Inland Rail Project - SSI No. 9371

North Star to Border

EIS Submission

Department of Planning, Industry and Environment

Attachment 2 ARTC preferred NS2B Alignment (with Flood Study)

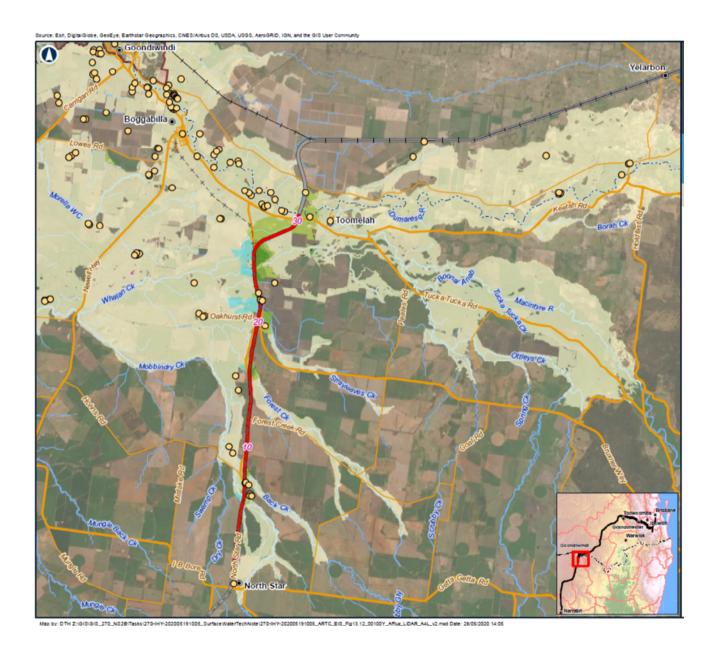
The corridor selected is between Toomelah and Boggabilla (Attachment 2) (**Eastern Alignment**), as compared to a more westerly alignment that would make greater utilisation of the existing rail corridor, and which would provide more direct access to existing intermodal sites at Boggabilla and Goondiwindi. Council understands that a more westerly alignment (Attachment 3) (**Western Alignment**) is strongly favoured by Goondiwindi Regional Council (**GRC**) and some landholders who are directly affected by the eastern alignment.

Council, while seeing the advantages of the western corridor for Goondiwindi and the northern portions of Moree Plains Shire, supports the Eastern Alignment in principle but acknowledges the views of GRC.

Key Point: The eastern alignment is acceptable to Moree Plains Shire Council while noting the preference of Goondiwindi Regional Council for the western alignment. If the Western Alignment is pursued, following a review of submissions, acceptable residential amenity in Boggabilla township needs to be maintained.

Attachment 3 GRC preferred NS2B Alignment (with Flood Study)

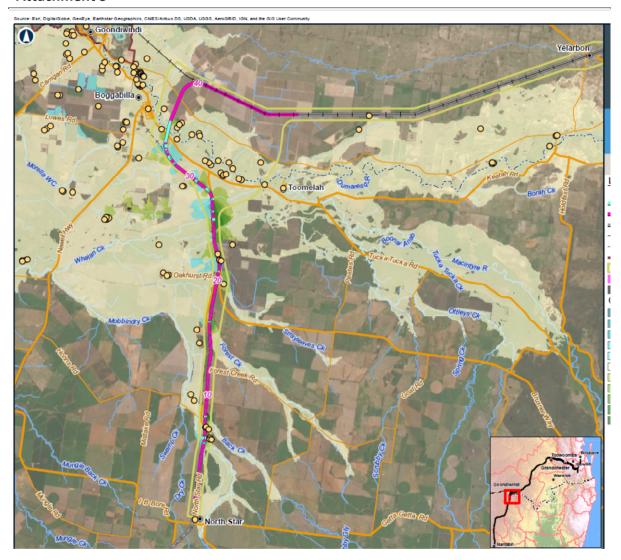
Subsequent development of the flood modelling has enabled a reasonably realistic comparison to be undertaken, noting concerns previously expressed through the technical committee regarding the "like-for-like" comparison between the two corridors. In particular, the additional afflux elements shown in association with the western corridor should have been addressed through further attention to bridge/culvert solutions to generate a similar afflux outcome upstream of each of the corridors. That being said, Council accepts that such additional work would likely have increased the cost differential however this would have enabled a more comprehensive comparison to be made.
